**South Florida Water Management District  
Central Everglades Planning Project  
Post Authorization Change Report, Feasibility Study and  
DRAFT Environmental Impact Statement  
Dated March 2018**

**ADDENDUM  
May 2018**

The following corrections, clarifications and augmentations are made to the Central Everglades Planning Project Post Authorization Change Report, Feasibility Study and Draft Environmental Impact Statement prepared by the South Florida Water Management District and submitted to the ASA(CW) in March 2018 for policy review under the authority of Section 203. This Addendum has been prepared by the SFWMD in response to the review performed by the ASA(CW) Project Planning and Review Office and Office of Water Project Review.

**Figure 4-10: Results of the Cost Effectiveness Incremental Cost Analysis for the Array of Alternatives**

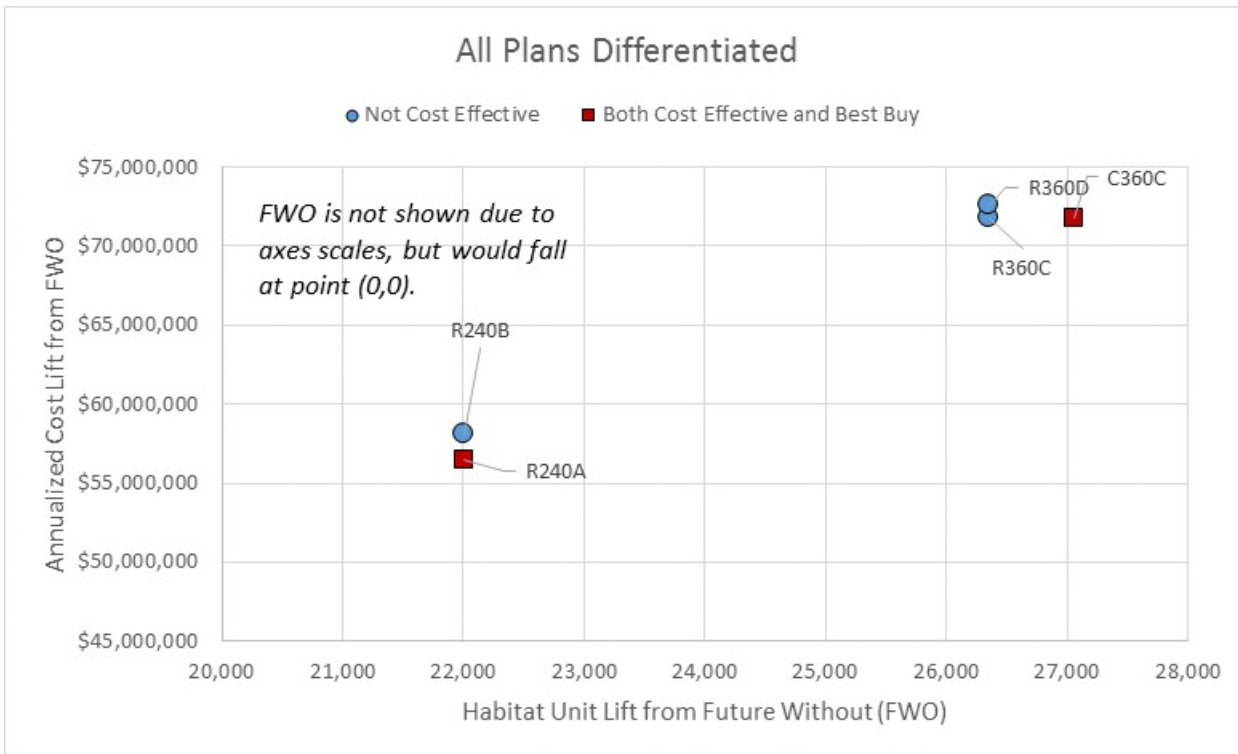
Page 4-20. The following figure is added as Figure 4-10 and subsequent figures are renumbered.

**Figure 4-12: Results of the Cost Effectiveness Incremental Cost Analysis for the Array of Alternatives and the Tentatively Selected Plan**

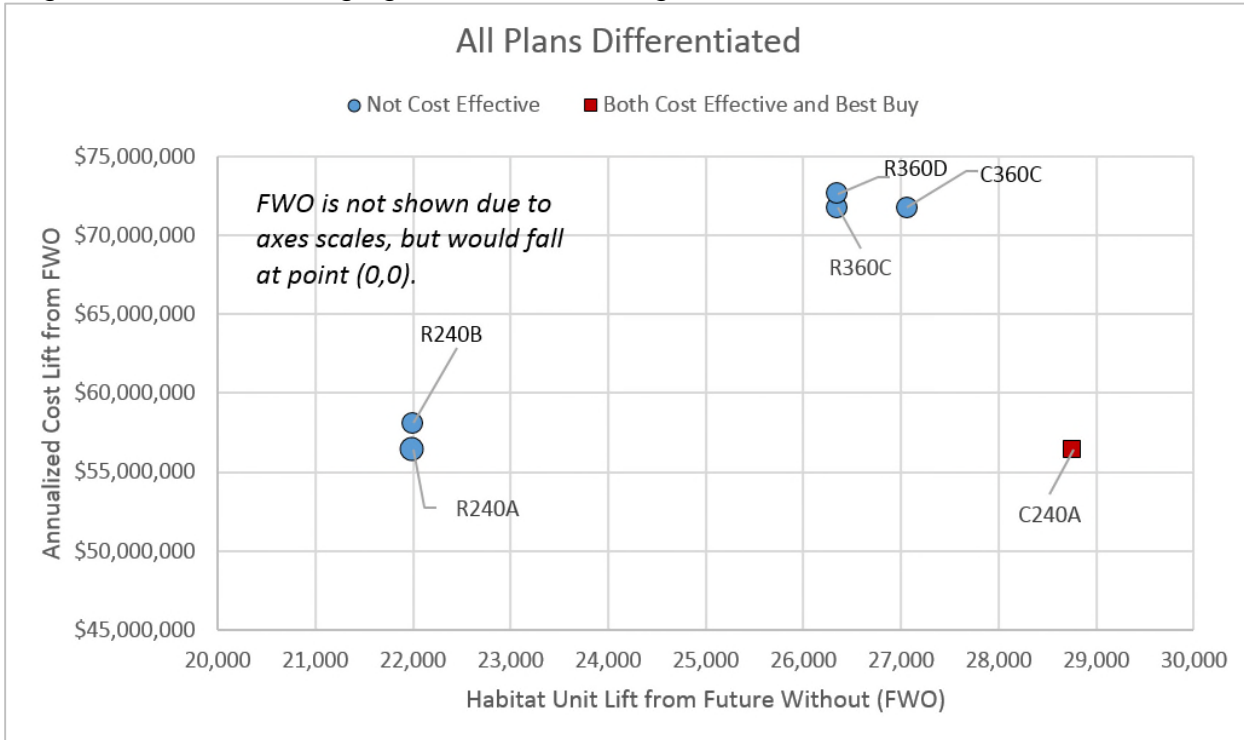
Page 4-27. The following figure is added as Figure 4-12.

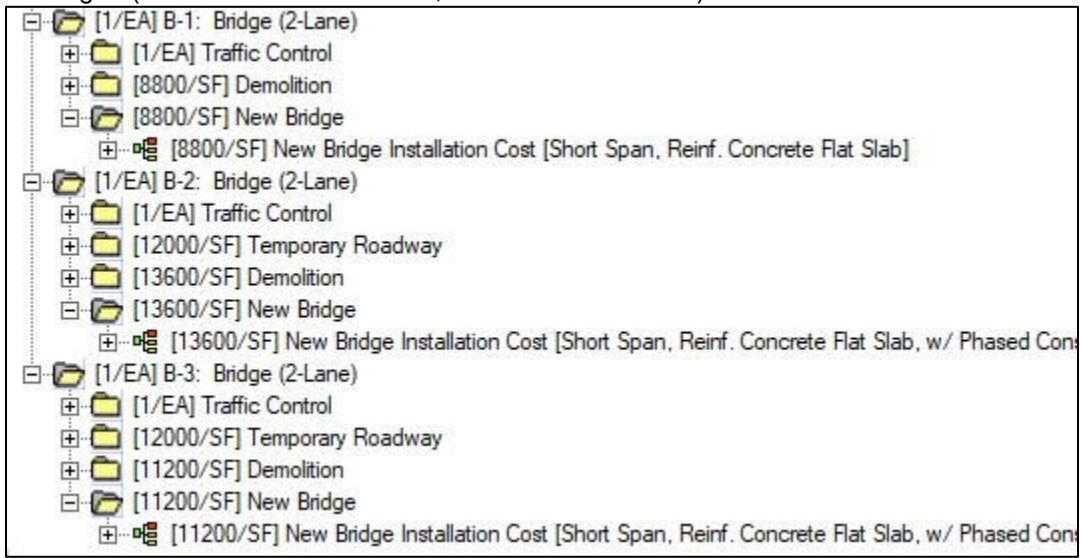
**Bridges:** The following items of concern are found Bridges B-1, B-2 and B-3.

- Bridges (Below is the MII estimate; QTOs should match.)

- QTO lists 3 bridges, all 200 ft long, with differing numbers of lanes.
- QTO assumptions section lists all 3 bridges as 2 lane.

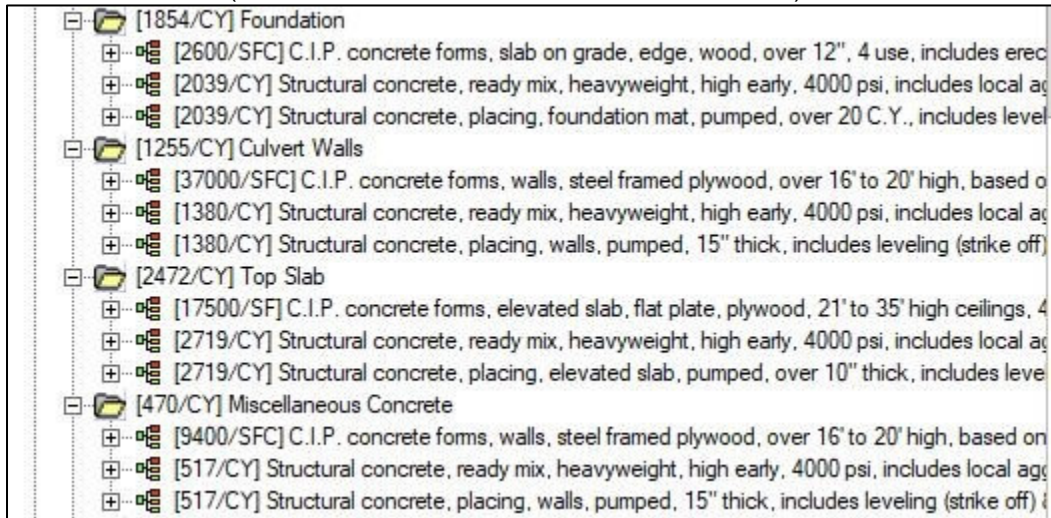
- Sheet Pile (Below is the MII estimate; QTOs should match.)

- QTO indicates 95767 sf.
- MII reflects 52000 sf.
- Possible error in QTO calculation.

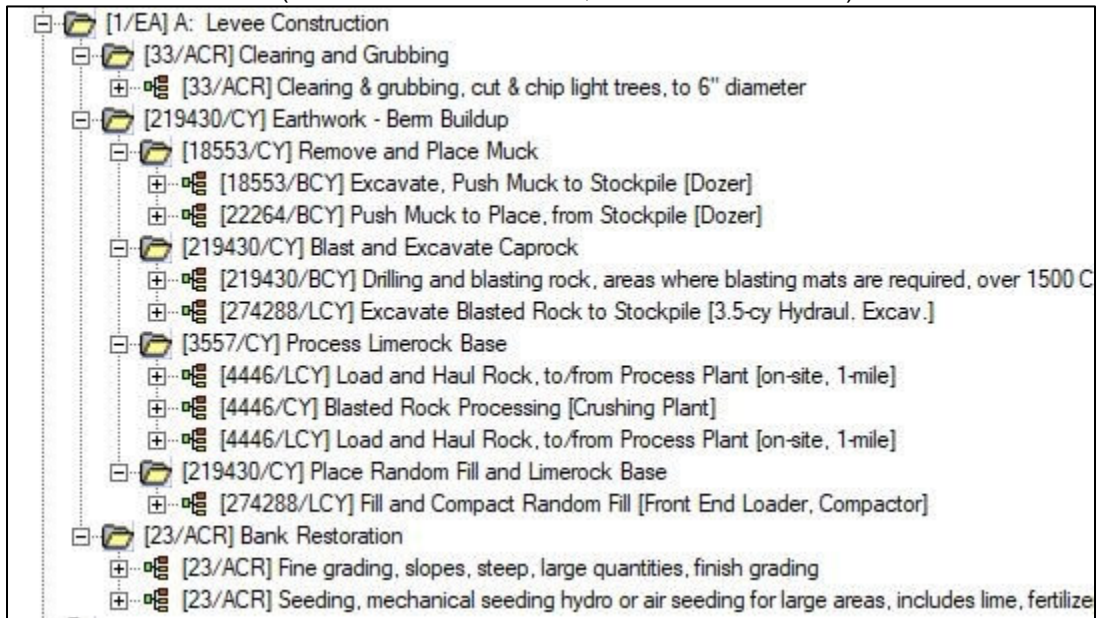
**Levees:** The following items are of concern in Levee A. While only Levee A was reviewed in detail due to time restraints, these observations, in whole or in part, apply to all levees on the project

- Levee Construction (Below is the MII estimate; QTOs should match.)

- QTO indicates random fill as 274288 cy.
- MII Random Fill folder label reflects 219430 cy.
- QTO does not specifically identify blasted rock quantity (labeling issue).
- MII reflects 219430 cy blasted rock.
- QTO does not identify 219430 cy as a quantity. One must assume it is the sum of 215873 cy and 3557 cy in the table.

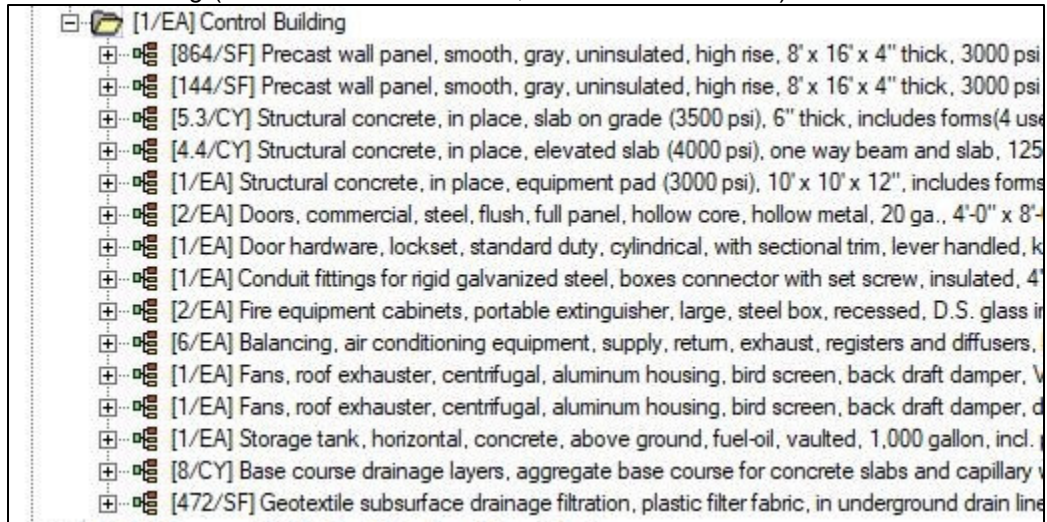
- Boat Barrier (Below is the MII estimate; QTOs should match.)

- QTO indicates 6 ea pile.
- MII reflects 240 lf piling.
- QTO unclear, should indicate assumed length of pile and calculation to lf.

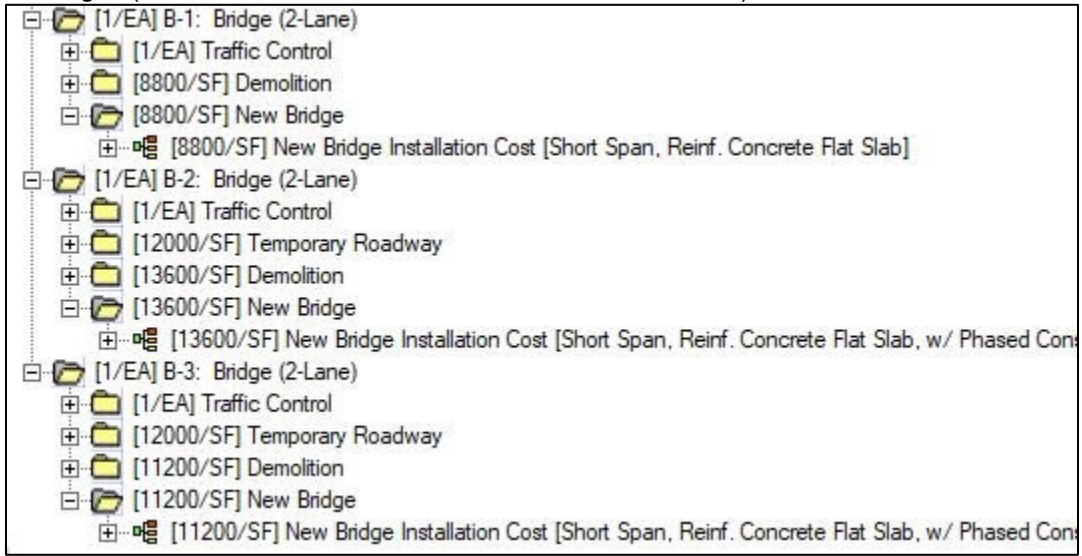
**Bridges:** The following items of concern are found Bridges B-1, B-2 and B-3.

- Bridges (Below is the MII estimate and QTOs should match.)

- QTO lists 3 bridges, all 200 ft long, but of varying roadway widths.
- QTO lists all 3 bridges as 2 lane.
- MII reflects 3 bridges having varying deck areas
- MII reflects all 3 bridges as 2 lane

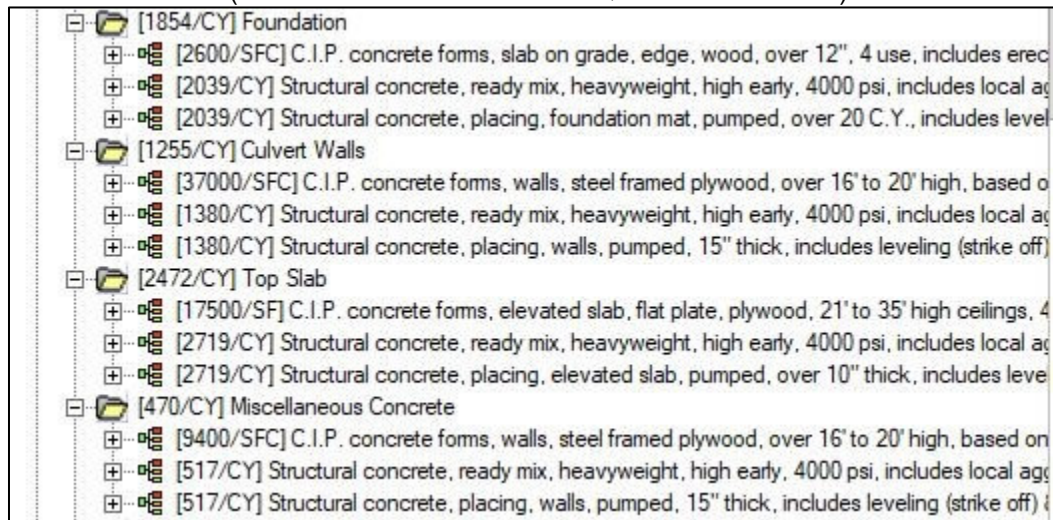
- Sheet Pile (Below is the MII estimate and QTOs should match.)

- QTO indicates 95767 sf.
- MII reflects 52000 sf.
- Possible error in QTO calculation.

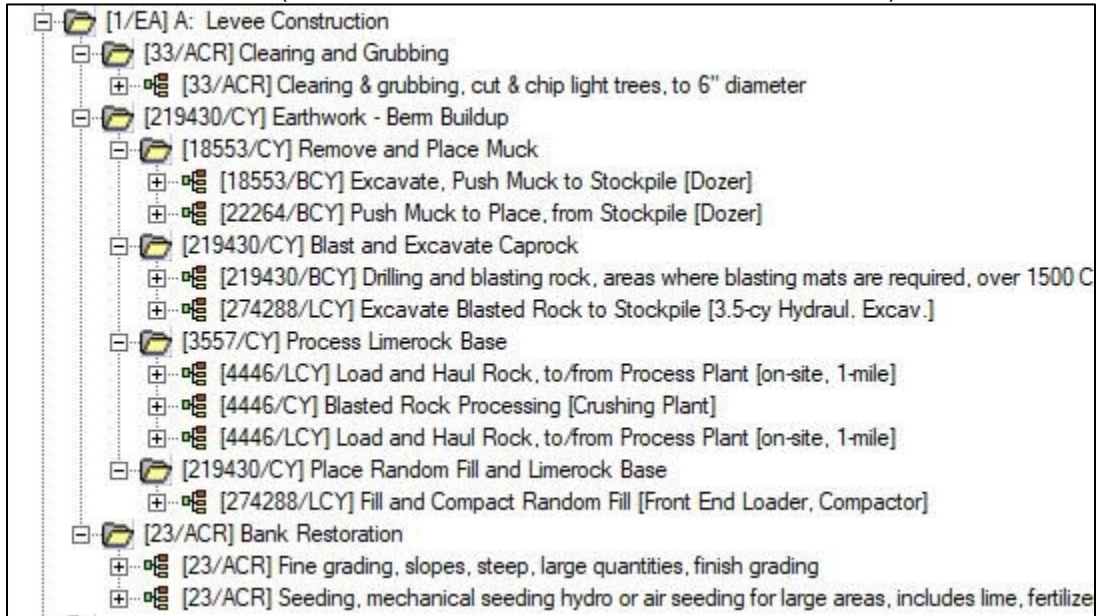
**Levees:** The following items are of concern in Levee A. While only Levee A was reviewed in detail due to time restraints, these observations, in whole or in part, apply to all levees on the project

- Levee Construction (Below is the MII estimate and QTOs should match.)

- QTO indicates random fill as 274288 cy.
- MII Random Fill folder label reflects 219430 cy.
- QTO does not specifically identify blasted rock quantity (labeling issue).
- MII reflects 219430 cy blasted rock.
- QTO does not identify 219430 cy as a quantity. One must assume it is the sum of 215873 cy and 3557 cy in the table.

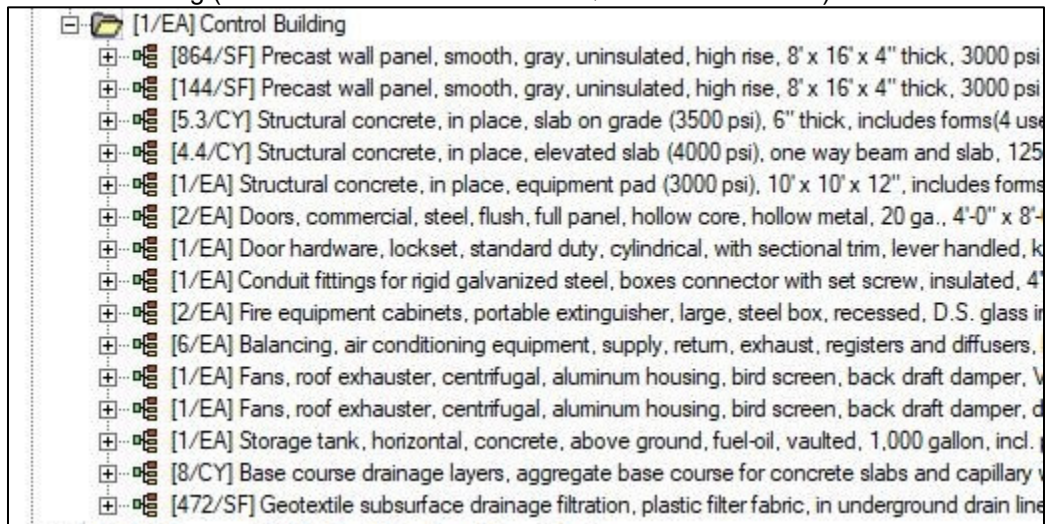
- Boat Barrier (Below is the MII estimate and QTOs should match.)

- QTO indicates 6 ea pile.
- MII reflects 240 lf piling.
- QTO unclear, should indicate assumed length of pile and calculation to lf.
- QTO indicates 340 lf of barrier.
- MII reflects 172 lf of barrier.
